RE: DNR Comment Letter Dated December 21, 2016 Regarding Review of Remedial Action Options Report

Former Koppers Tar Plant and Wabash Alloys Site
9100 S. 5th Avenue, Oak Creek, WI
BRRTS # 02-41-553761, FID # 241379050
Connell VPLE BRRTS # 06-41-560058
Beazer VPLE BRRTS # 06-41-561509

This letter provides Beazer's response to the Wisconsin Department of Natural Resources (DNR) December 21, 2016 comment letter concerning the subject Remedial Action Options Report (RAOR) for the Former Koppers Tar Plant and Wabash Alloys Site, and the City of Oak Creek Utility Corridor, Lot 1 (collectively hereinafter, the "Site"). Below we have provided your comments followed by our responses in italics.

MW-122

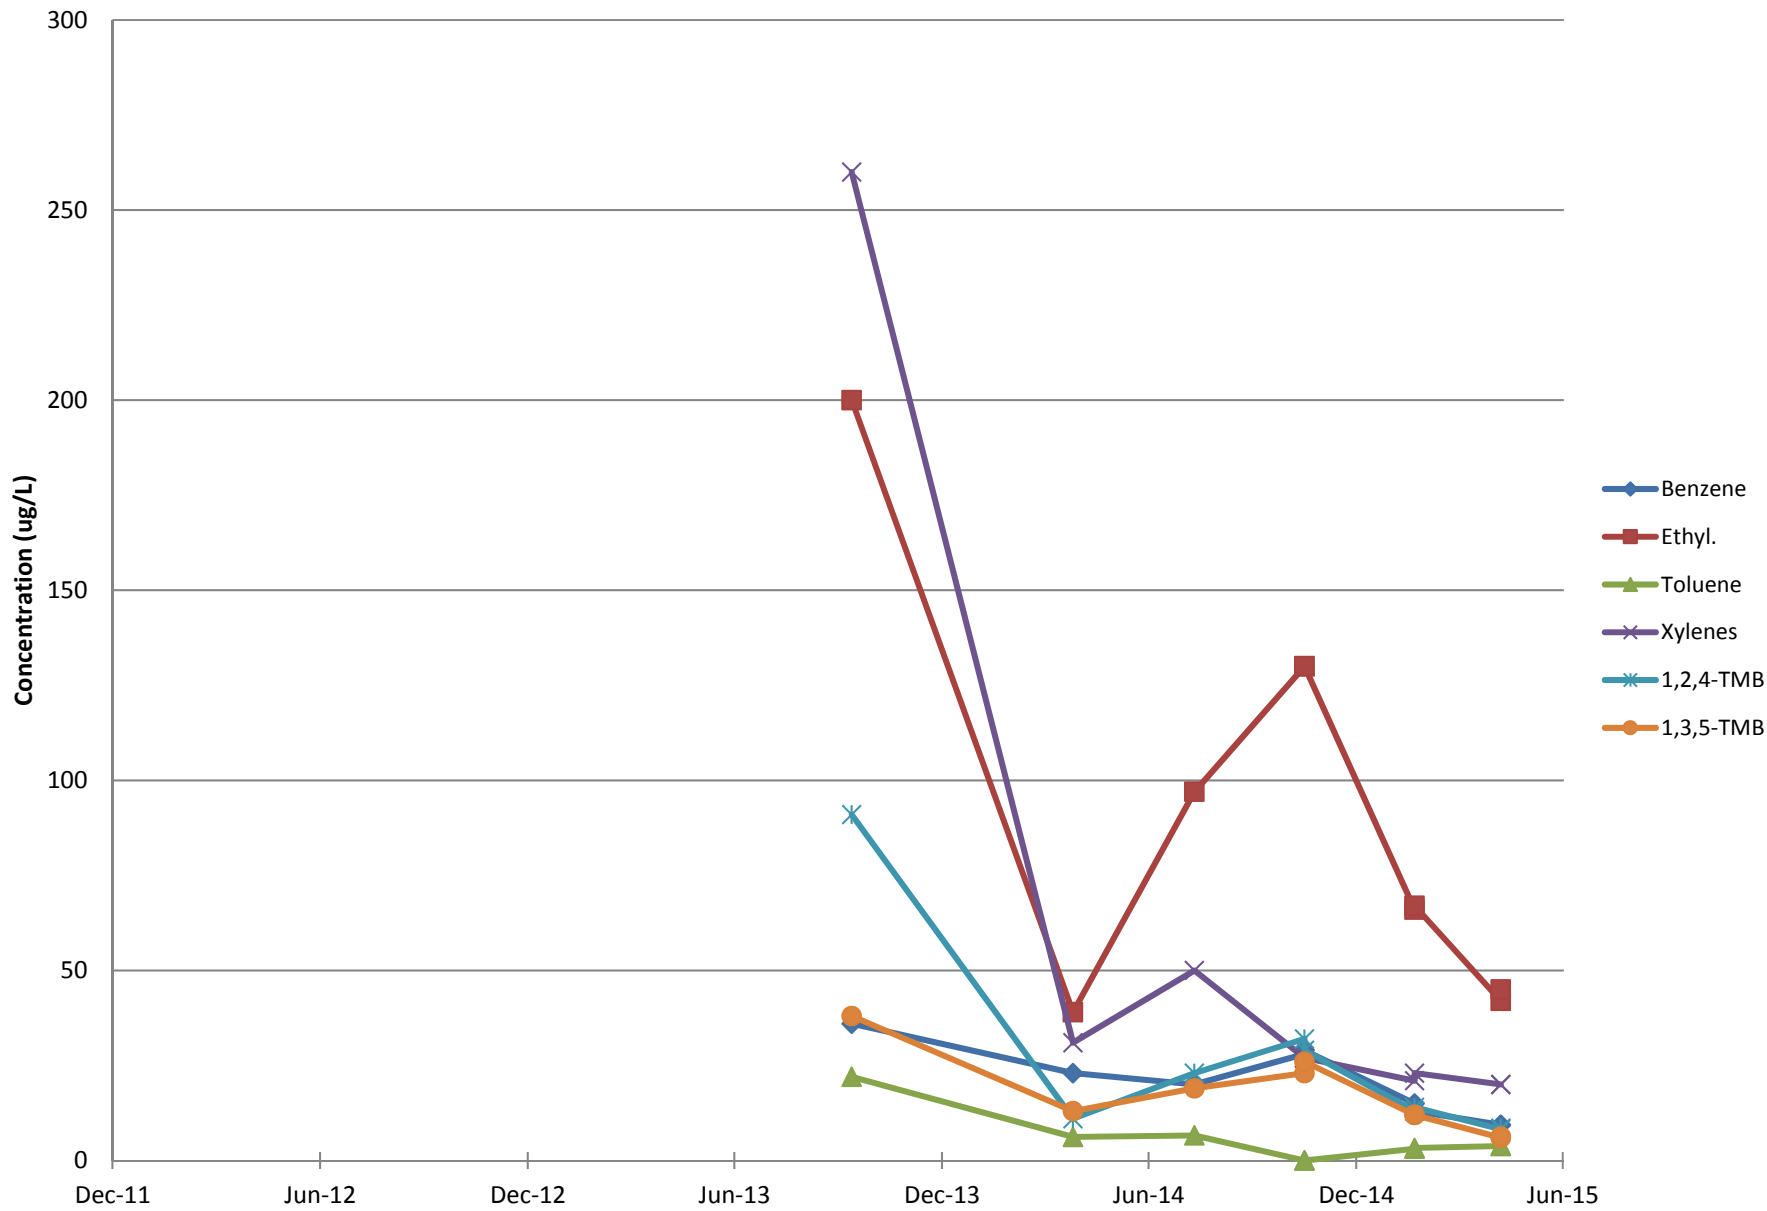
Monitoring to date has not demonstrated that there are naturally occurring biodegradation processes that are expected to reduce the mass of contamination within any reasonable time frame. Based on the extent to which the coal tar and associated high levels of contamination have spread laterally and vertically, it does not appear that the contamination source is stable or receding. The minimal groundwater sampling in water table wells adjacent to the site has not been, and likely will not be, successful in demonstrating a stable source or reducing contaminant mass. The presence of significant contamination extending to depths of more than 20 feet is indicative of a mobile source and contaminant plume. No assessment has been completed to determine the rate of movement of the contaminant mass, nor the potential impact(s) of the contamination to possible receptors. Even with additional source removal, more wells and associated monitoring will be needed to determine the stability of the plume. The proposed cap does not provide any infiltration protection from the precipitation of rain and snow, and thus does not prevent or limit continued leaching of contaminants to groundwater and surface water features via infiltrating precipitation.

Contrary to the DNR comment above, groundwater monitoring does show stable or declining concentrations in monitoring wells within and downgradient of areas of tar and along the utility corridor as shown in the attached charts. For example, wells MW-122, MW-123 and MW-125 are located within areas of observed tar and in close proximity to former source areas. BTEX and PAH concentrations in those wells all show declining concentrations over 8 quarters of monitoring. Wells MW-108, MW-115 and MW-118 are 50-200 feet downgradient of source areas and show sporadic low level detections all below groundwater standards. Likewise wells along the utility corridor (MW-1, MW-2, MW-112, MW-131, MW-132, and MW-134) show stable or declining BTEX and PAH concentration trends. Beazer acknowledges that additional groundwater monitoring may be necessary, including the possible need for additional wells and associated monitoring, to demonstrate the stability of the plume during long term monitoring.
